Walker Custom Homes 500 NW Main

Recommended 1st Floor Placement Plan

SHOP DRAWING SUBMITTAL REVIEW
This review is for general conformance with plans and specifications only. Approvals are subject to contractor's performance within the confines of the contract documents. Review of dimensions will not serve to relieve the contractor of contractual responsibility for any deviation from the contract requirements.

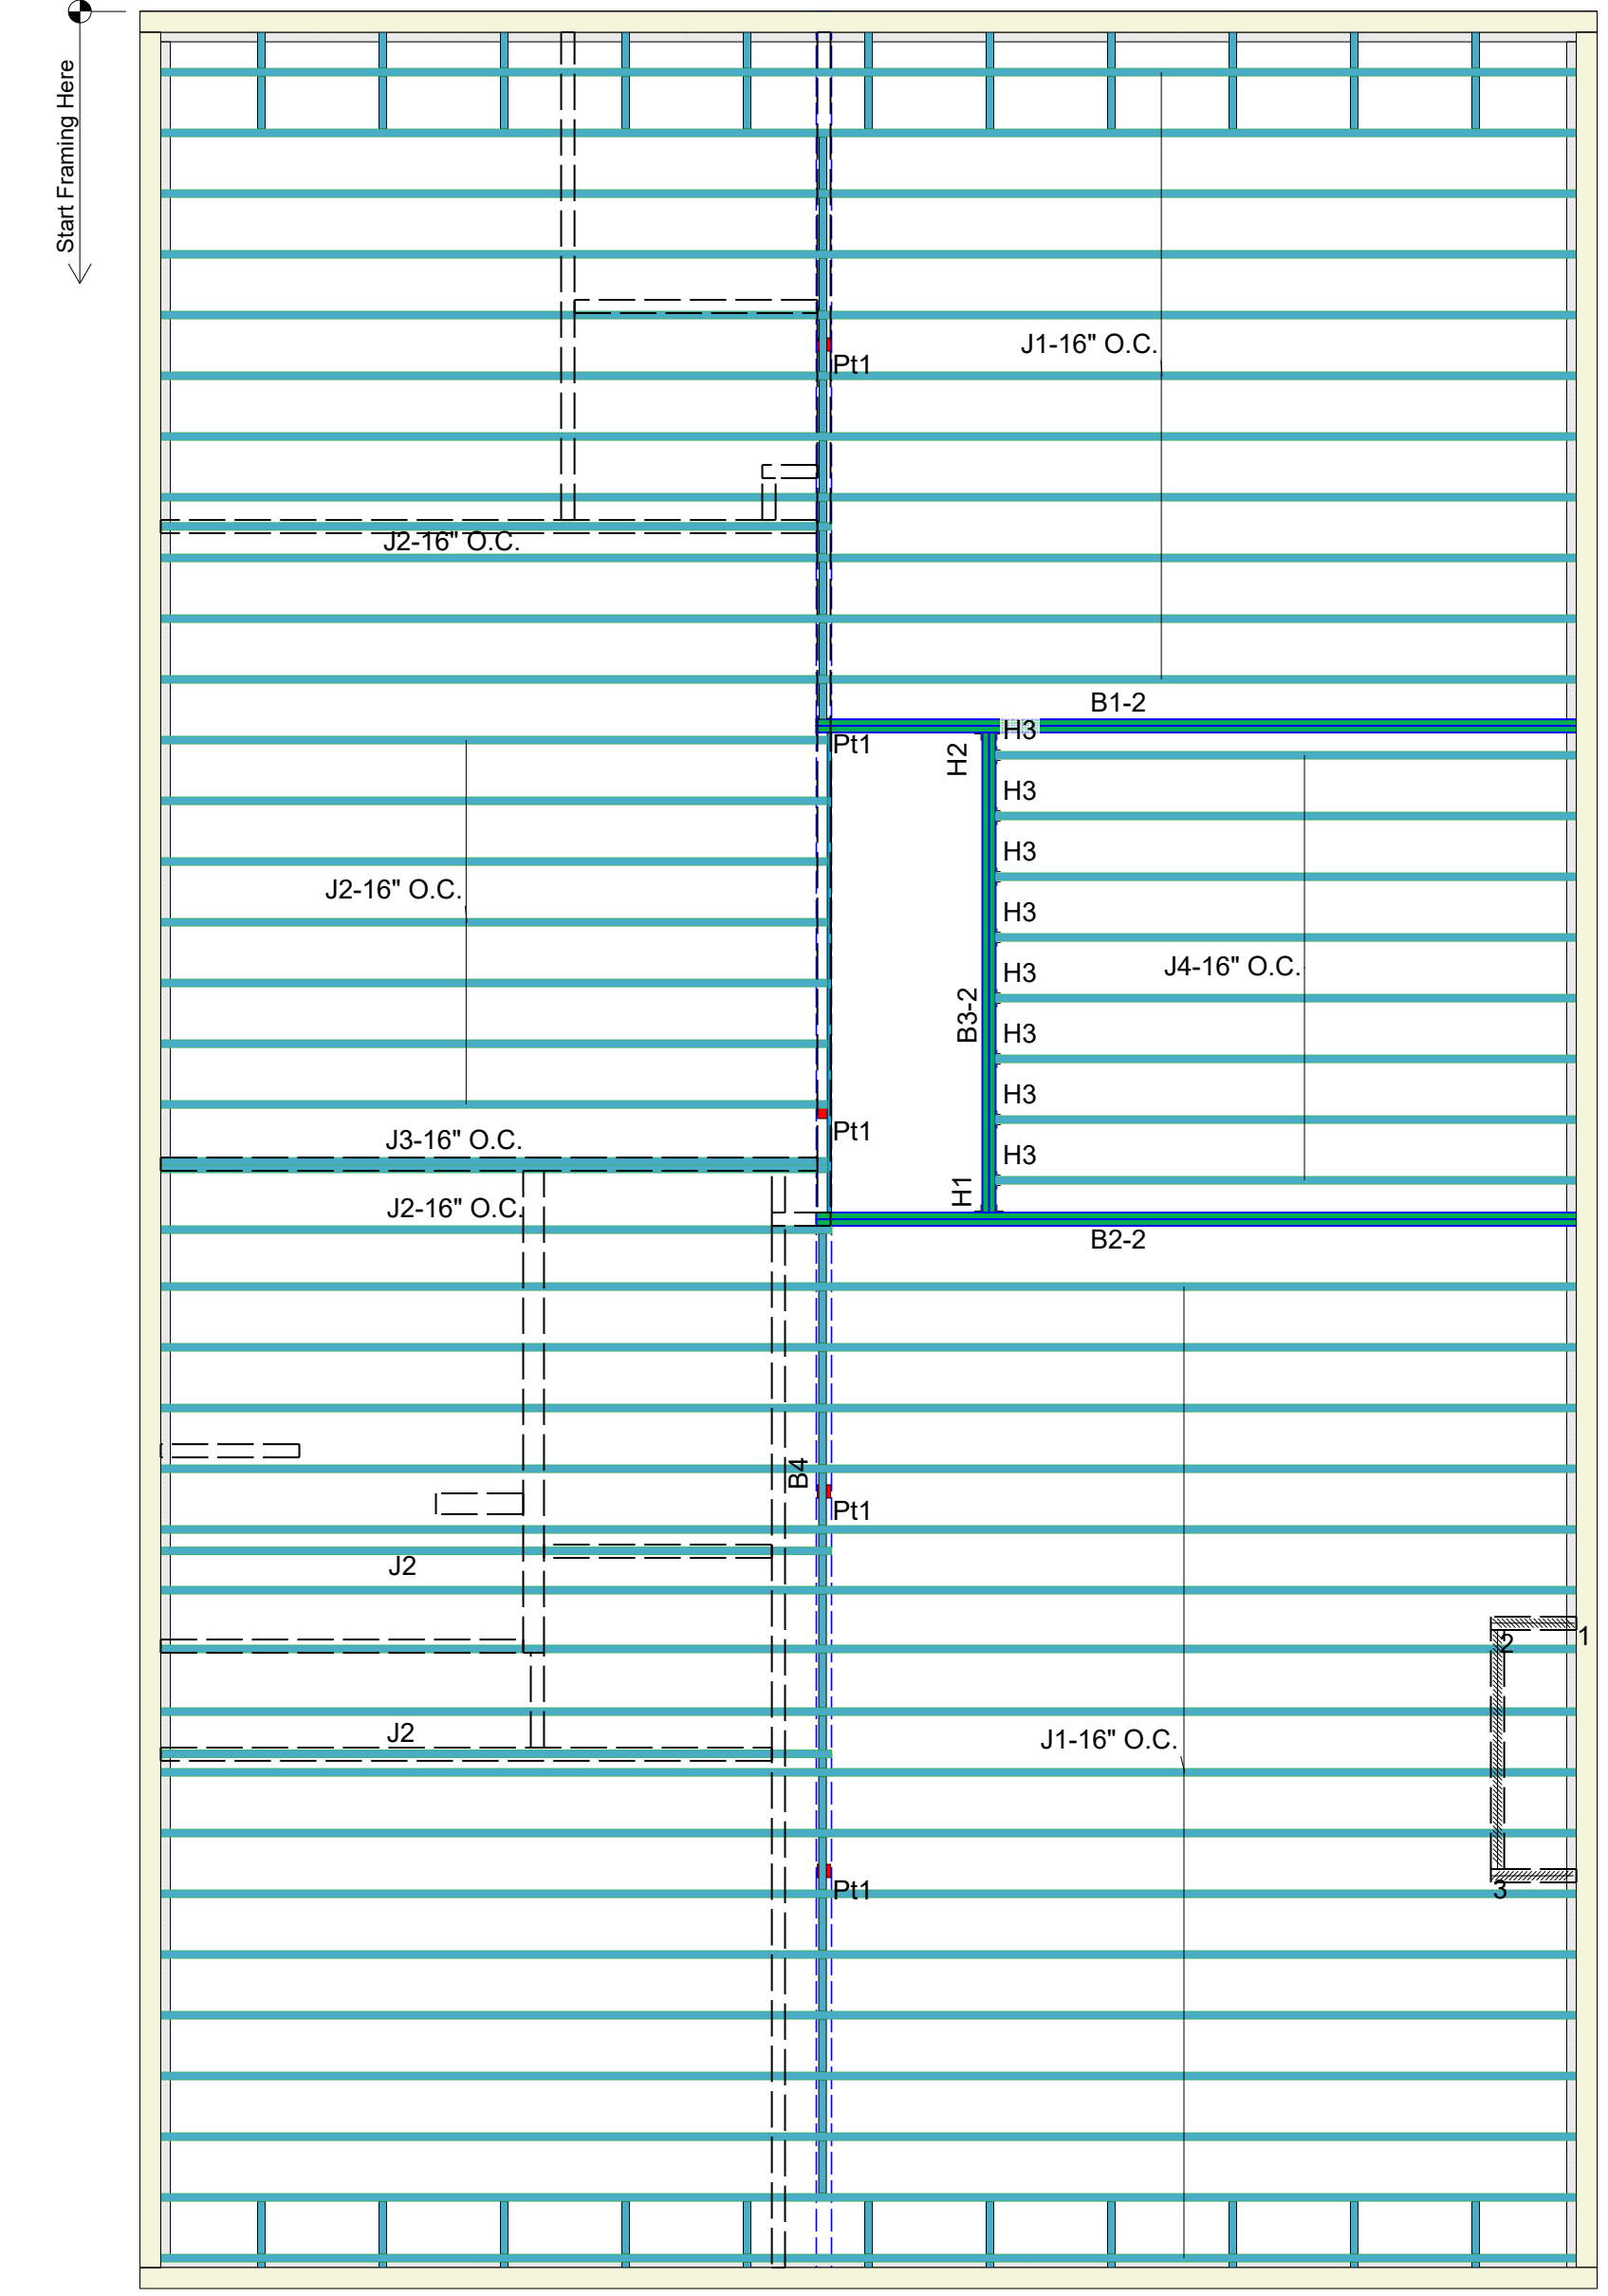
B1-2 IS STRUCTURALLY ADEQUATE AS 9 1/2" LVL'S. 11 7/8" LVL'S MAY BE USED IN PLACE OF 9 1/2" LVL'S IF DESIRED BY THE BUILDER.
